## Reply for RC1

## Reply for RC2

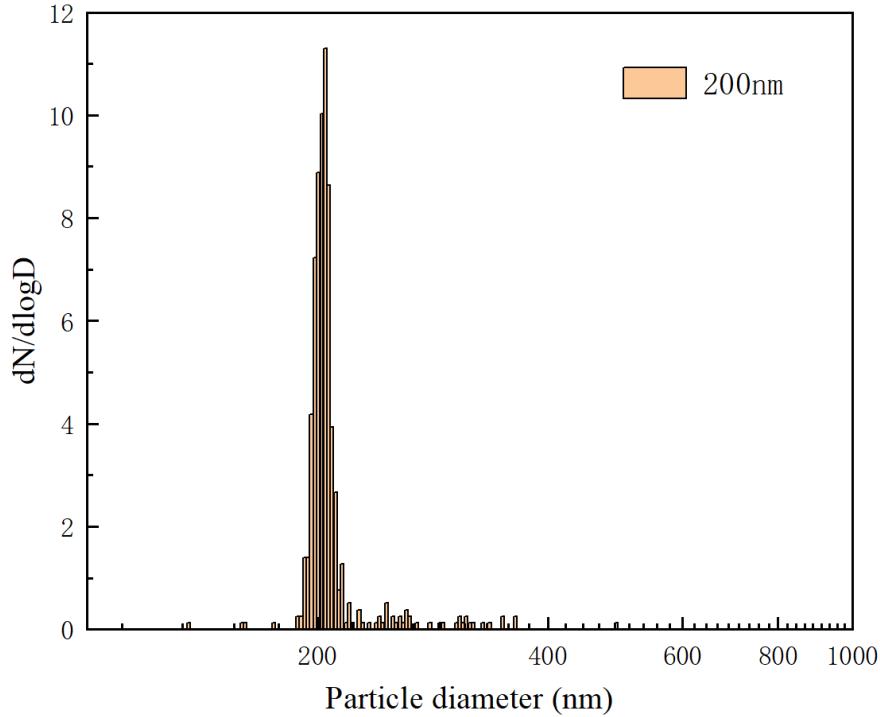
**Q1:** There are multiple lines of evidence that put the experimental TE results of Fig 7, and the uncanny agreement with simulation, into question. A) Most of the values are exactly 100%, which is highly suspect, and include no error bars showing variability. B) As written, the reference system for submicron sizes (a CPC without a DMA) is incapable of accurately counting PSL generated by nebulization, assuming that many (typically very many) non-PSL (surfactant) particles are also generated. C) The simulated particle trajectories in Fig 6 show that particle beam widths at the detection laser(s) are much larger than a typical SPAMS laser beam width (Du et al., 2024). Therefore a large fraction of the simulated particles would not be detected by SPAMS, and experimental TEs cannot be at or near 100%. Furthermore, it is very likely that these simulated beam widths provide a lower limit, and the actual particle beam widths are probably much larger.

**A1:** We thank the reviewer for the careful examination of the paper. For issues (a) and (b), the authors performed experimental tests on the transmission efficiency of PSL spheres using SMPS. The figure below shows the particle size distribution when generating 200 nm particle, indicating that the produced particles are primarily 200 nm, with no smaller particles generated. The calculation of transmission efficiency has been defined in Section 2.3, and specific test results are shown in Fig. 6, with error bars added based on the experimental results. Regarding issue (c), the authors would like to clarify that the Bio-SPAMS used in this study is not the same as Du et al.'s HP-SPAMS, and a different laser is employed. This study utilized the Sony SLD3234VF laser, which has a beam width of 3 mm, larger than the beam width shown in Fig. 6, thus it will not affect particle counting.

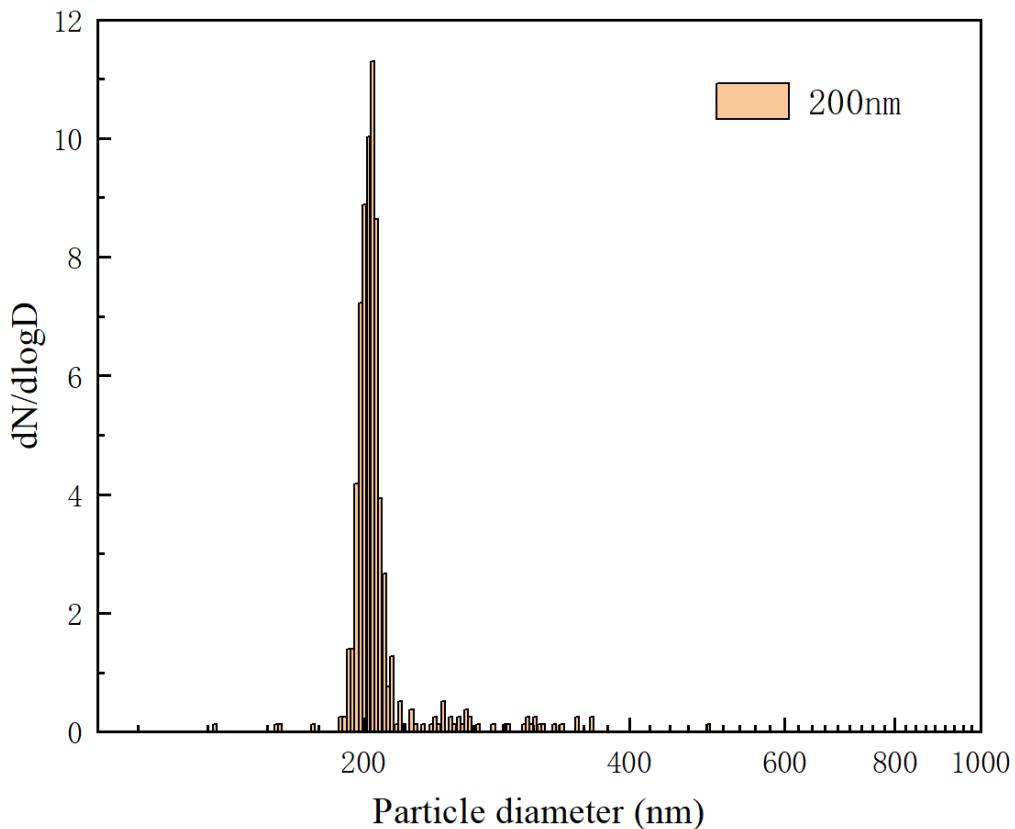
**Q5:** I do not understand how you can count PSL particles with the CPC without also counting the surfactant particles from the atomized solution.

**A5:** We sincerely appreciate the reviewer's thoughtful feedback. I would like to thank the reviewer for the careful examination of this paper. The authors conducted experimental tests on the transmission efficiency of PSL spheres using SMPS, and error bars have been added based on the experimental results. The figure below shows the

particle size distribution when generating 200 nm particles, indicating that the produced particles are predominantly 200 nm in size, with no other smaller particles generated.
